Professional Audio Service Bulletin

Mincom
Division **3M**
COMPANY

SUBJECT: Signal Electronics PC Board FET Replacement

FIGURE 1

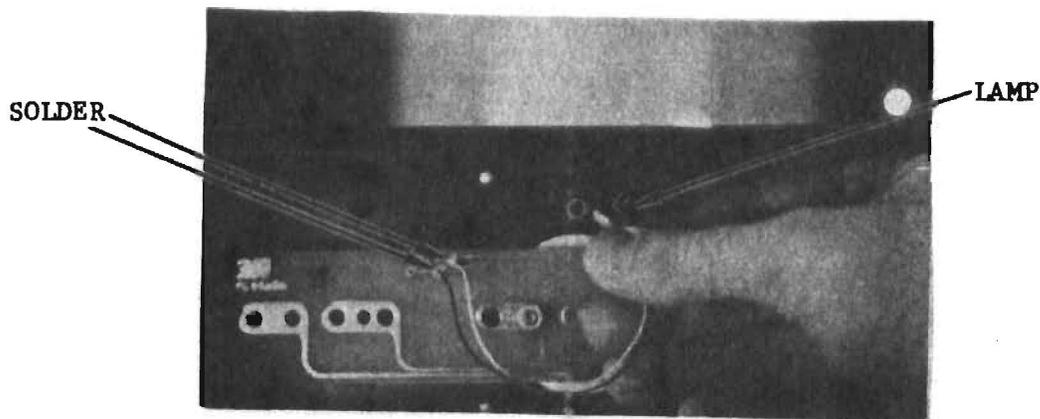
- I. Remove MURA type meter lamp from the white line cap above the meter and unplug the wires from meter mother board.
- II. Solder wires on lamp holder 83-1620-0294 in place of the removed wires on the mother board (see Figure 1).

FIGURE 1

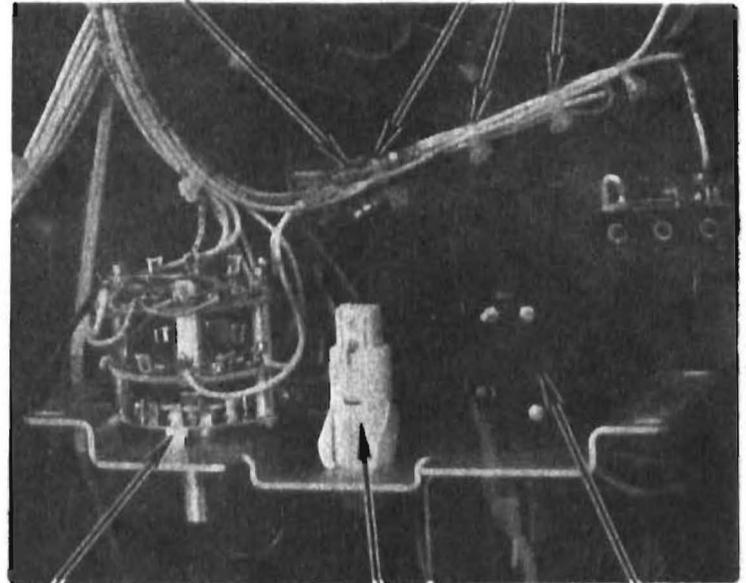
- 5) Remove the four Phillips Screws that hold the Capstan Speed Switch Assembly to the deck. This allows the Switch Assembly to drop back far enough to replace the Stripper plate. See Figure 1.

FIGURE 2

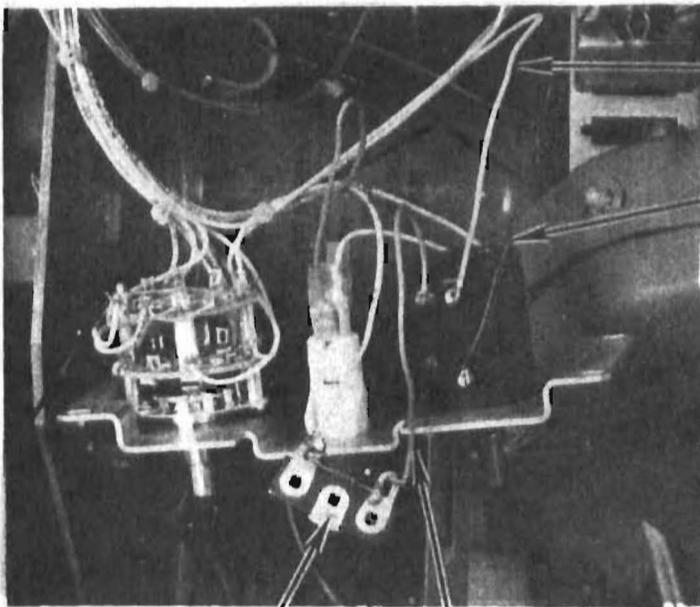
- 6) Mount Amber Lamp and 2.5 K ohm Variable Resistor. See Figure 2
- 7) Remove Ty-raps that secure wires with the Amp Connectors and connect to Amber Lamp. See Figure 2 and 3.

FIGURE 4

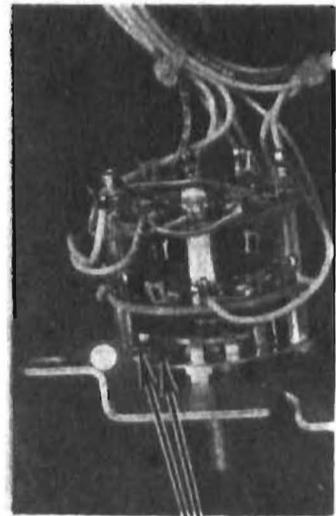
- 10) Solder the Black ground wire marked R2/3 → TB3 to the lug on R2 as shown in Figure 3.
- 11) The two tabs located on the Capstan Speed Switch S3 should be bent down, this adds the two positions for Var Hi and Var Low when the Knob is turned clockwise. See Figure 4.

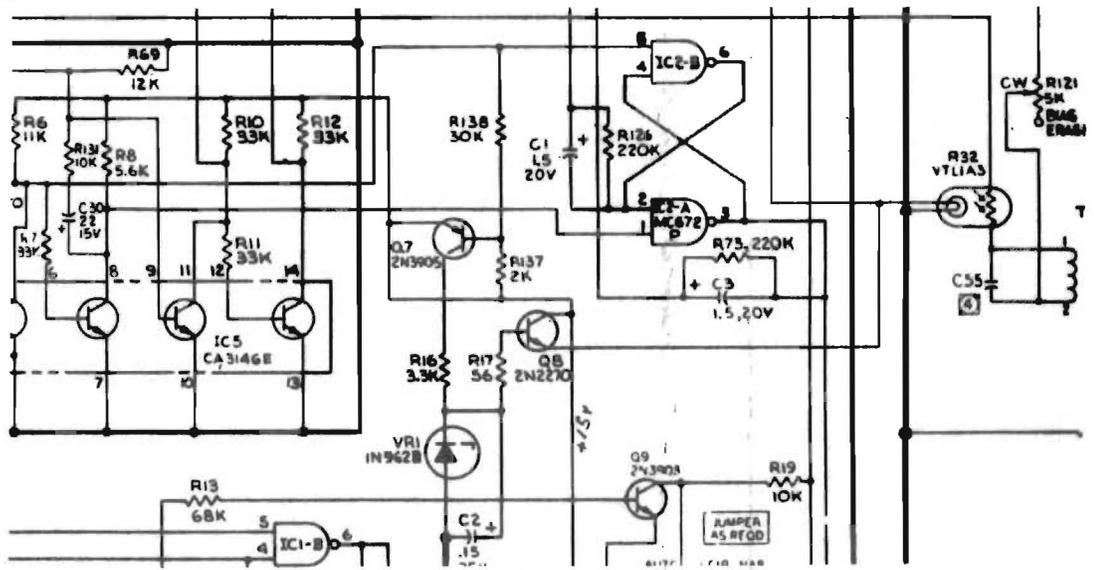
Change the Signal Electronics Schematic in the Manual to show the Modification

2N3905 TO18-4 Case

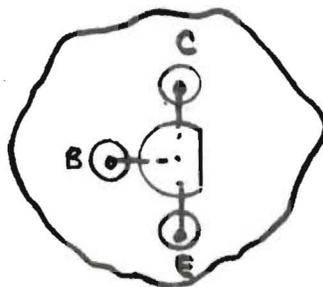
Due to a change in lead configuration on the 2N3905 TO18-4 case (round), it will be necessary to install this transistor as shown:

FIGURE 1

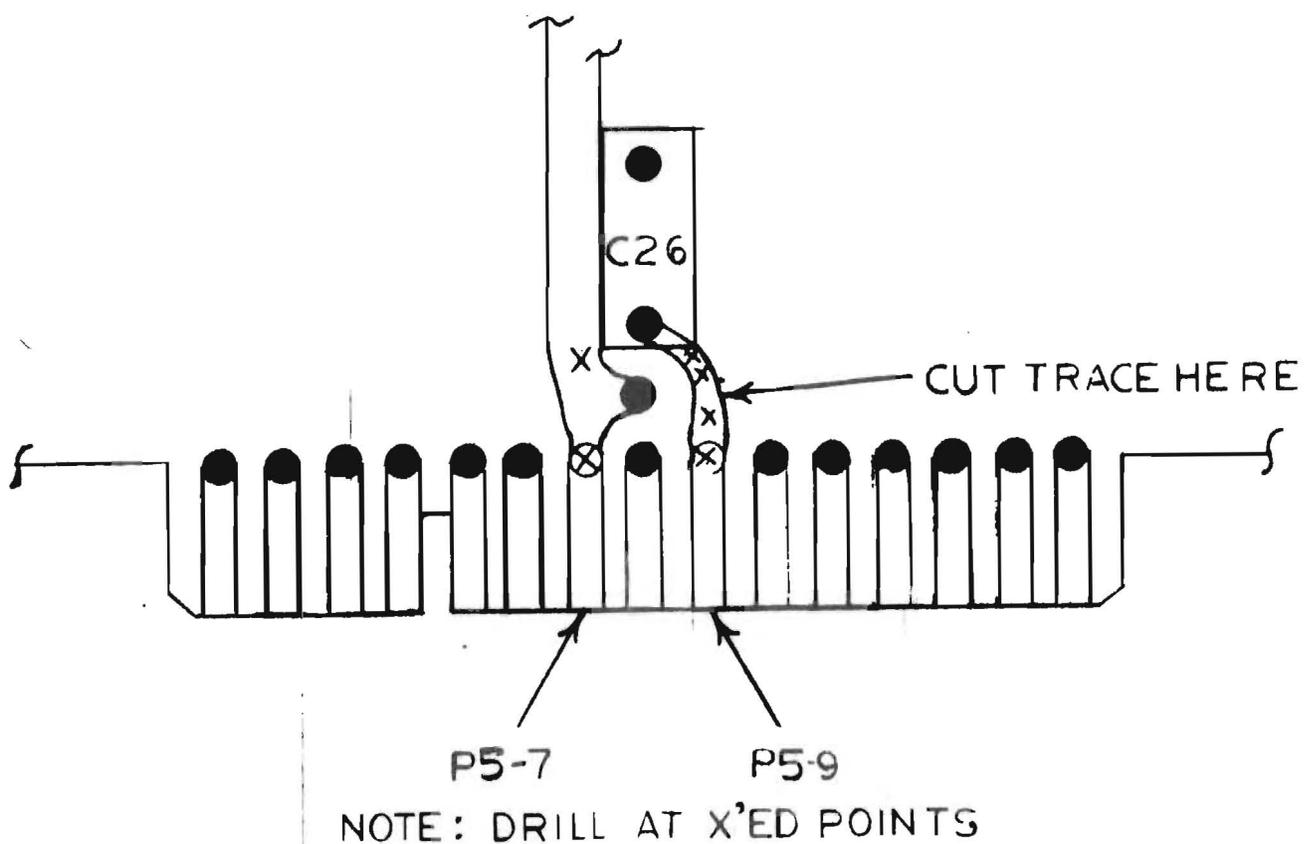
- V. Utilizing the drill motor and the #70 twist drill, put 6 holes thru the PC Board. Location of these holes are as follows: (See Figure I)
- A. Top of Contact Finger #9
 - B. Top of contact Finger #7
 - C. Between contact Finger #9 and cut in trace.
 - D. In trace running to the left of C-26 near lower left hand edge of C-26.
 - E. Between cut in trace and bottom of C-26, drill 2

FIGURE 2

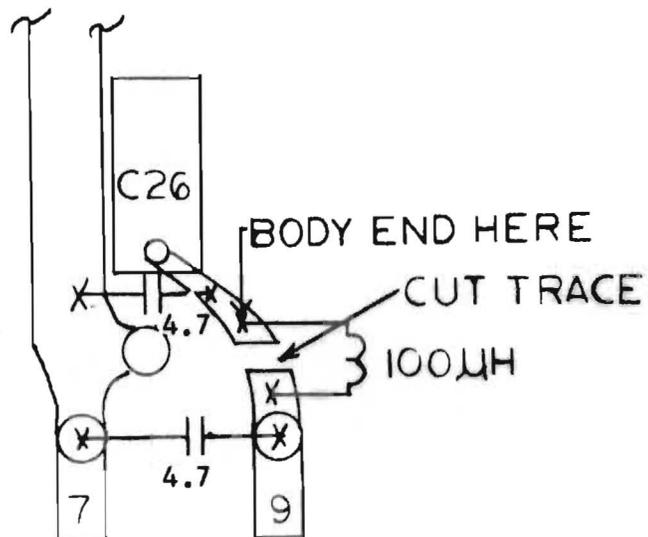
- VI. Install 4.7uf capacitor between holes drilled at top of contacts 7 & 9.
(See Figure 2)
- VII. Install 4.7uf capacitor between holes drilled just below and to the left and right of C-26. (See Figure #2)
- VIII. Install 100μh coil in two remaining holes (See Figure 2)

FIGURE 1

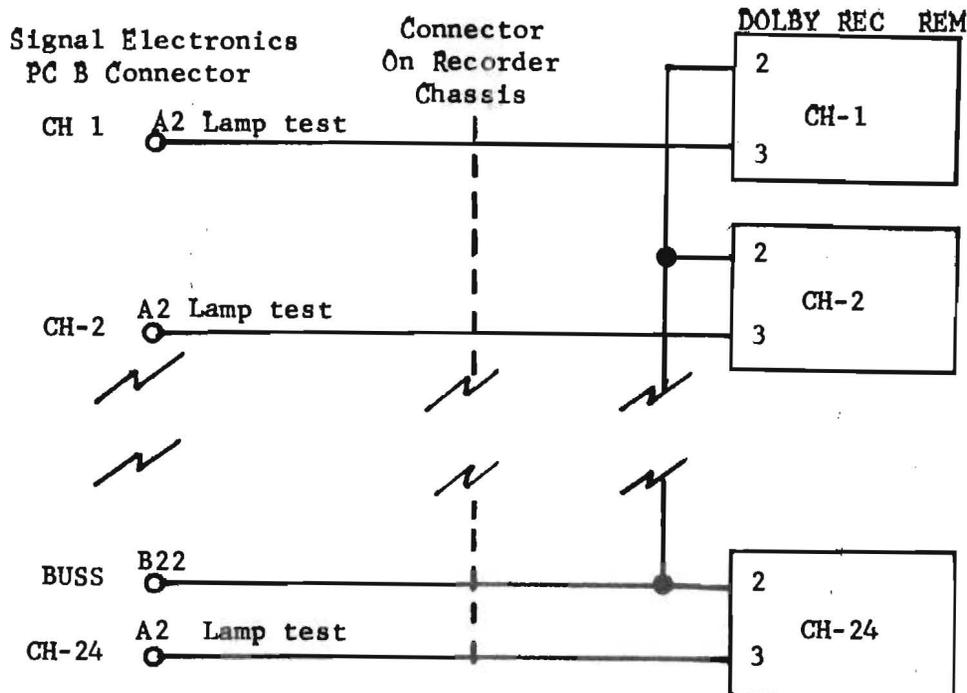
Remote connection of M series DOLBY units to M-79 (see figure 1).

1. Connect pin A-2 of each channel signal electronics pc board to pin 3 of the DOLBY unit through a suitable connector on the recorder chassis.
2. Connect pin B-22 bus on signal electronic pc board pin 2 of ALL DOLBY units.
3. Insure R102 and R108 in CAT 44 Interface Module are 6.8 K ohms (earlier models had 2.7 K ohm or 3.3 K ohm resistors); if the resistors are not the correct values, replace them with resistors of the correct value.

FIGURE 2

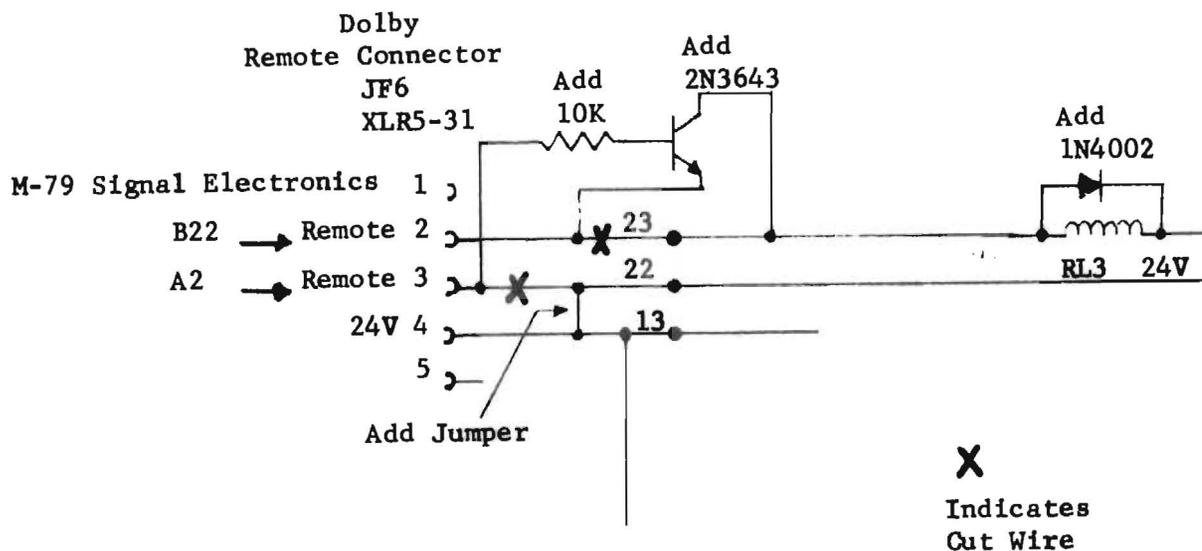
1. Connect Pin A2 of each M-79 Signal Electronics PC Board to Pin 3 of the DOLBY Remote Connector through a suitable connector on the recorder chassis.
2. Connect Pin B-22 buss on the M-79 Signal Electronics PC Boards to Pin 2 of ALL DOLBY units.
3. Modify DOLBY interface by adding circuit as shown in Figure 2.
NOTE: Refer to DOLBY 361 Interface circuit in the DOLBY Manual.

FIGURE 6

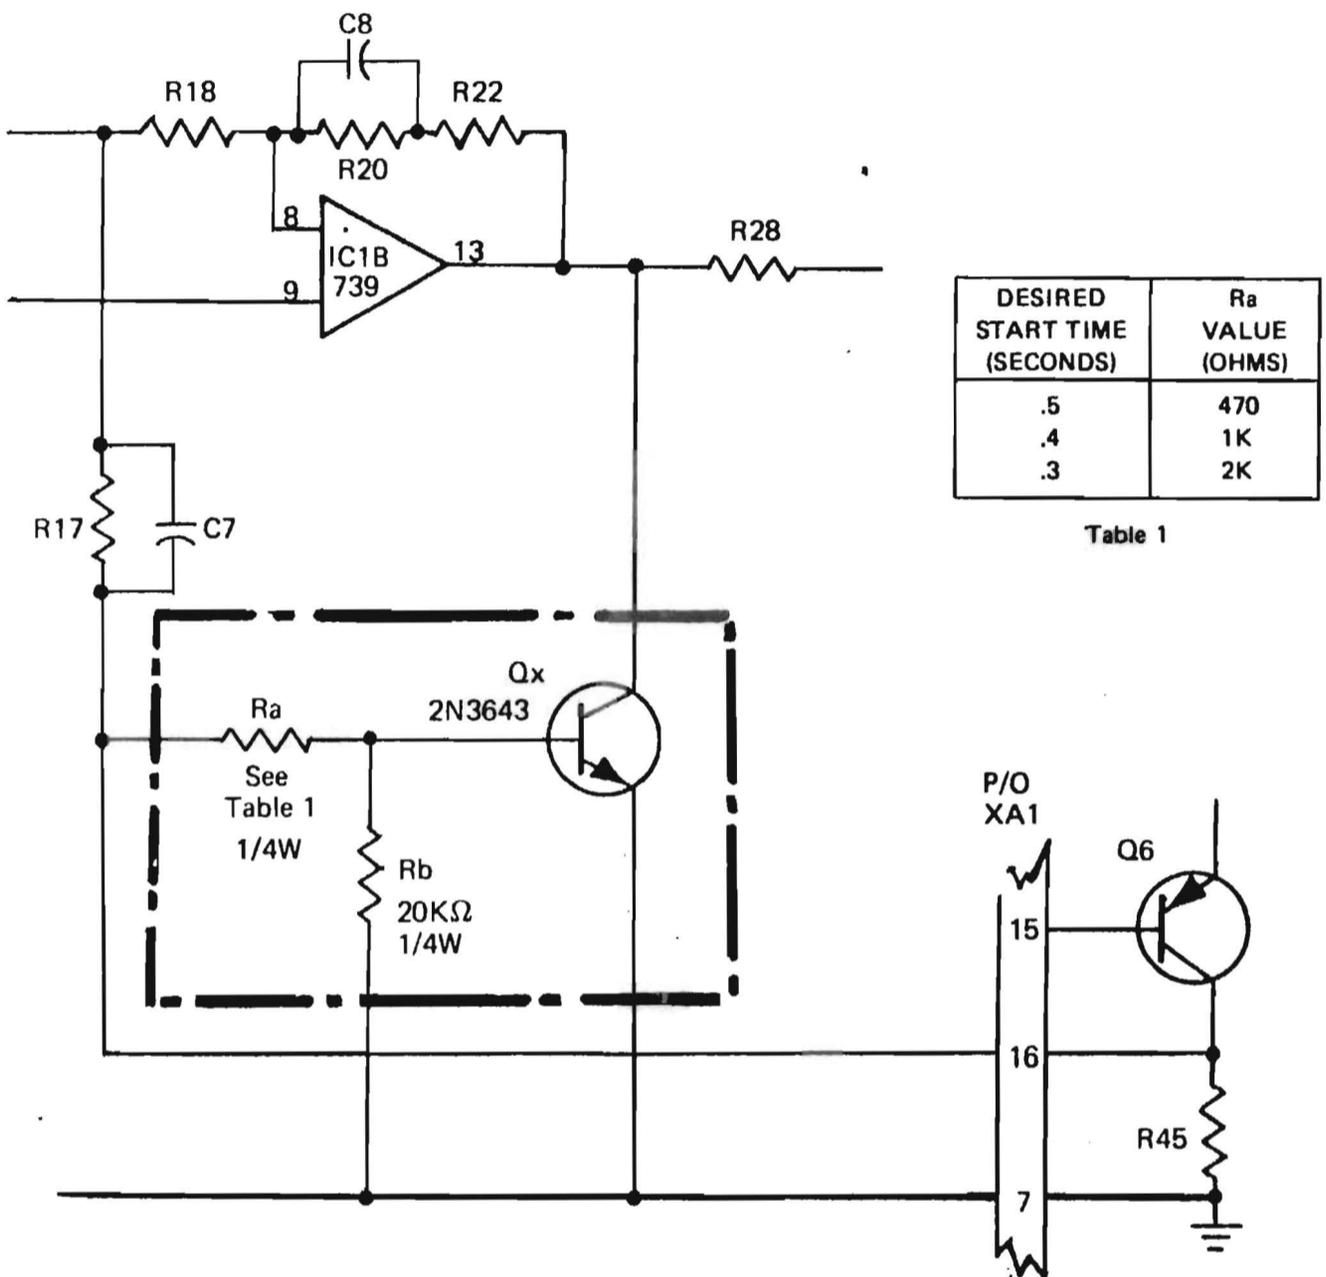
7. Modify Capstan Servo p.c. board (see figure 6).
 - a. Connect resistor Rb between GROUND and the base of Transistor Qx.
 - b. Connect resistor Ra between the junction of R17 and C7 (junction nearest to p.c. board side) and the junction of Rb and Qx base.
 - c. Connect the emitter of Qx to ground.
 - d. Connect the collector of Qx to the junction of R28 and IC1B pin 13.
8. Adjust capstan servo p.c. board pulse width and speed if necessary.
9. Perform reel alignment procedure.

FIGURE 1

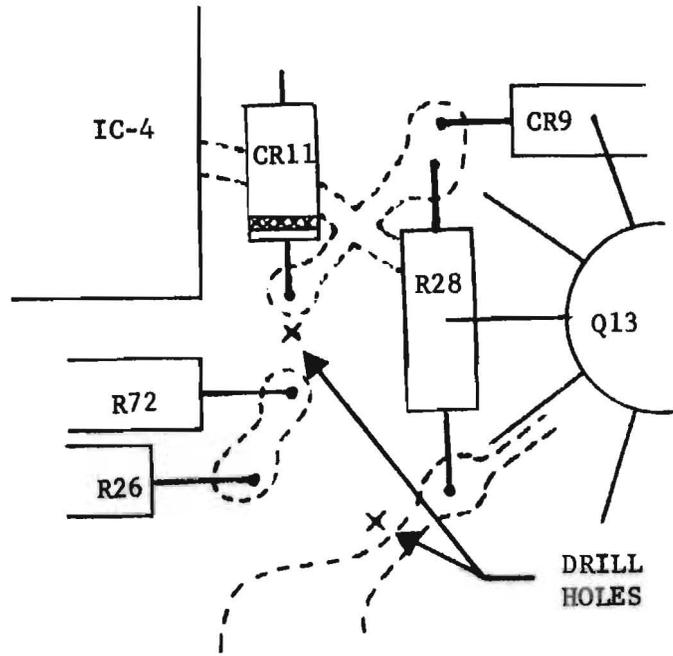
1. Drill two holes .030/.035 inches in diameter at points in figure 1.

FIGURE 1

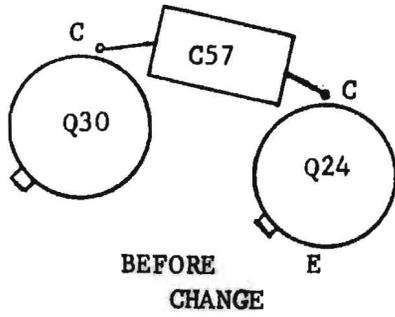
1. Remove Capacitor C-57 which is connected between the collectors of Q-30 and Q-24 (see figure 1).
2. Drill one hole using a .030/.035 inches, drill adjacent to the emitter connection of Q-24 (see figure 2).

FIGURE 3

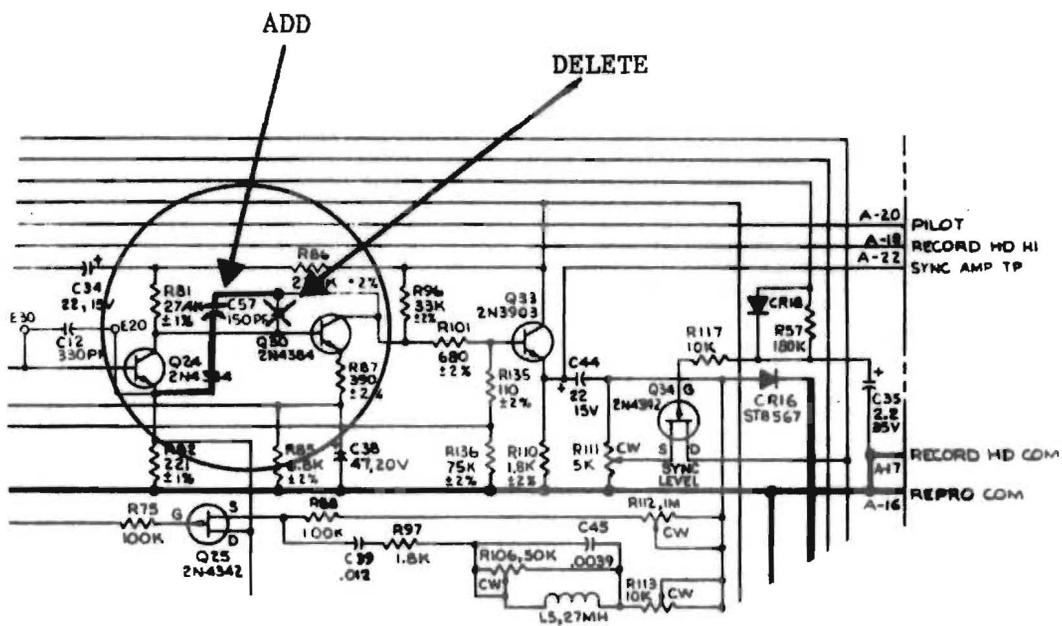
3. Install the new 560pf capacitor, designated C-57, between the collector of Q-30 and the emitter of Q-24 (see figure 2). Insert capacitor lead through new hole, then bend the lead to the emitter trace of Q-24, then solder.
4. Check Recorder alignment and adjust if necessary.
5. Change Instruction Manual schematics and parts list to reflect the new location of C-57 as indicated by figure 3.

FIGURE 1

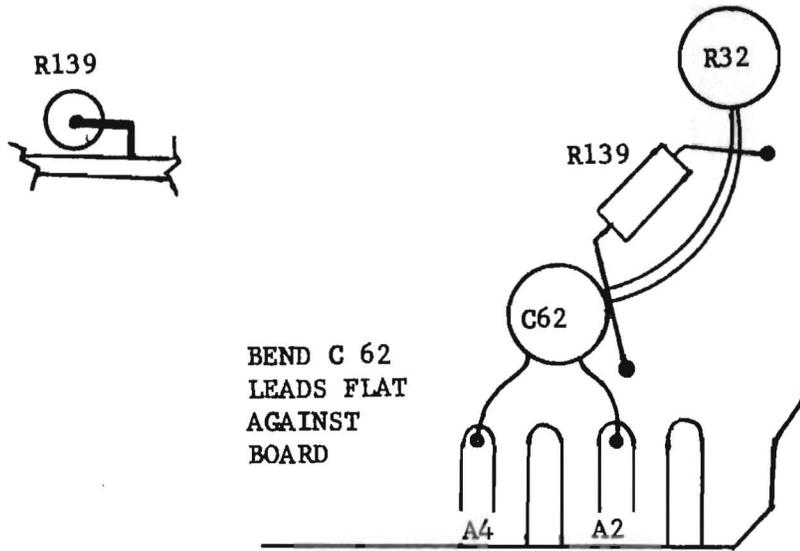
1. Drill four holes .041/.046 inches in diameter at points indicated on figure 1.

2. Cut the printed circuit trace as indicated on figure 1.
3. Install the capacitor, designated C-62 in the holes drilled in the finger contacts (see figure 2). Insure the leads lie flat against the board to prevent shorts to the board brace.
4. Install the resistor, designated R139, as indicated in figure 2. Bend the leads to make contact with the trace on the back of the board and solder. R-139 must be bent as shown to prevent accidental short circuits and to permit the board to be installed in the Recorder.
5. Change Instruction Manual schematics (see figure 3) and parts list to reflect C-62 and R-139.

Figure 1

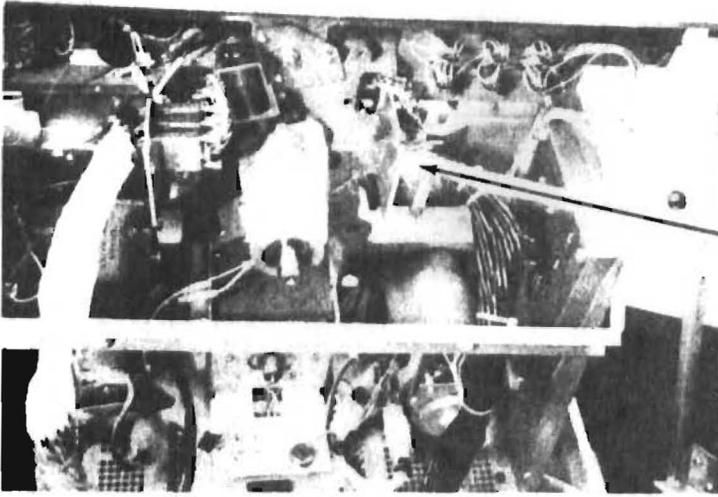
- b. Install new bracket assembly onto transport. (Figure 1)
 - c. Reconnect head connector(s). (Figure 2)
4. Repeat steps 2 and 3 above for bracket on record side.

Figure 3

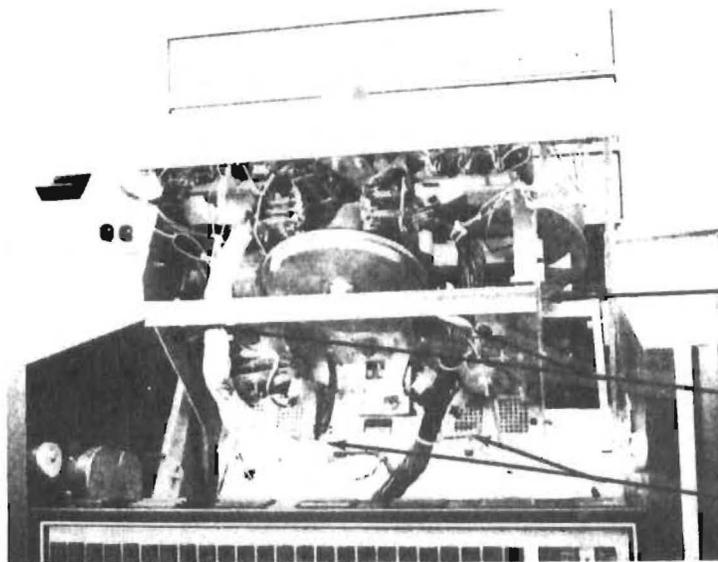
9. Reinstall capstan belt and refer to section 4-30 of the manual for belt tension adjustment.
10. Reinstall lower belt cover.
11. Install head cable mounting bracket 83-3320-2962 as shown (Figure 3). Use existing screw on right side, use 8-32 x 1/2" screw on left side.

12. Attach head cables to bracket using clamps removed in step 1f. Use 10-32 hardware furnished (Figure 3).
13. Install a spring from each head cable bundle to rear of transport wrap around (See Figure 3).
